TRU Solutions LLC

February 23, 2009

Subject: RESPONSE TO REQUEST FOR ADDITIONAL INFORMATION FOR REVIEW
OF AN APPLICATION FOR REVISION 22 OF THE TRUPACT-II SHIPPING
PACKAGE APPLICATION (DOCKET No. 71-9218, TAC No. L24217) AND
REVISION 5 OF THE HalfPACT SHIPPING PACKAGE APPLICATION
(DOCKET No. 71-9279, TAC No. L24218)

Figure CH-1.1 - Headspace Hydrogen Profile Predicted by AltMeth for Drum No. SR510338A

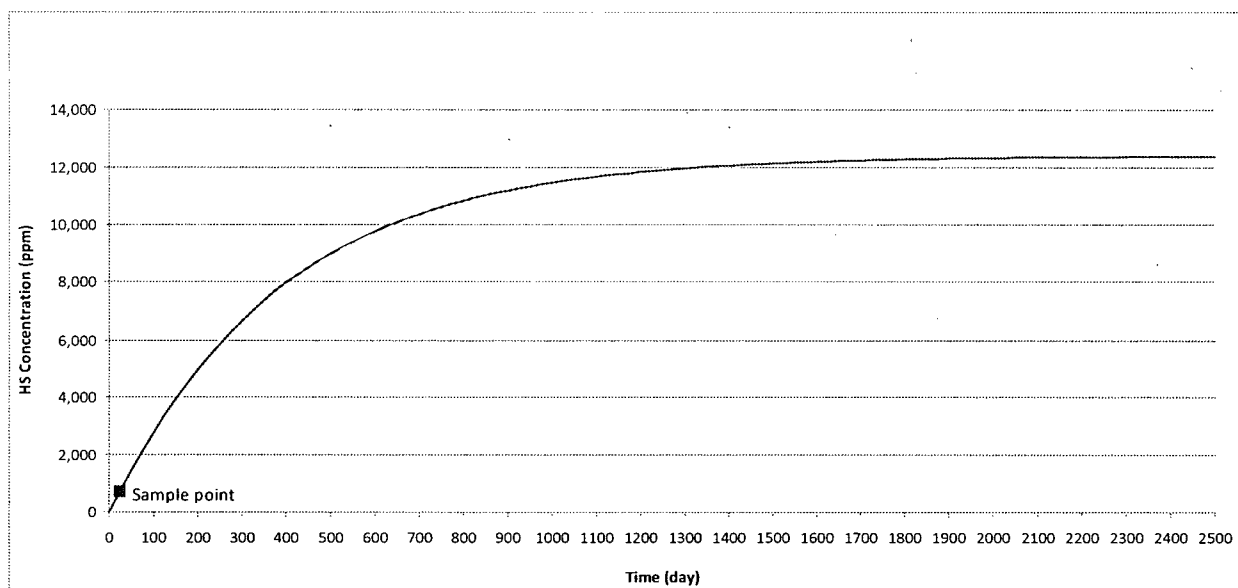
New: Characterize the analytical category shipments that show unqualified FGGR limits in the validated set and provide a methodology to exclude them from the analytical category. Alternatively, the applicant should justify why the current configuration of the analytical category drums and methodology ensure that hydrogen concentrations will not exceed 5% even without headspace sampling. Specify the phenomena and waste configurations of the analytical category shipments that result in hydrogen concentrations that are not as conservative as initially expected.

The applicant stated in the CH-2 RAI response that an analysis of the estimated FGGR for individual drums shows that approximately 96% of the 9,665 drums have measured headspace sampling hydrogen concentration values that comply with the assigned payload shipping category FGGR limits. The applicant indicates the drums in the remaining 4% of the data set comply with the 5% hydrogen concentration limit based on the reported headspace hydrogen concentration data and other mitigating factors.

As a specific example, no detectable hydrogen was measured in the headspace of Drum No. SR510338A. The hydrogen detection limit value of 700 ppm (0.07 volume percent) was used in the simplified AltMeth model. With the large number of layers of confinement for this container (five) and a short time interval between drum generation/venting and sampling (25 days), the AltMeth measurement methodology results in a high FGGR. Figure CH-1.1 shows a graphical depiction of the headspace hydrogen profile for this drum. The gradient between the headspace and the innermost confinement layer predicted by AltMeth for this drum is greater than a factor of 70 (7,000%). When combined with the use of the hydrogen detection limit value, this results in an overprediction of the FGGR value even when no hydrogen is detected.
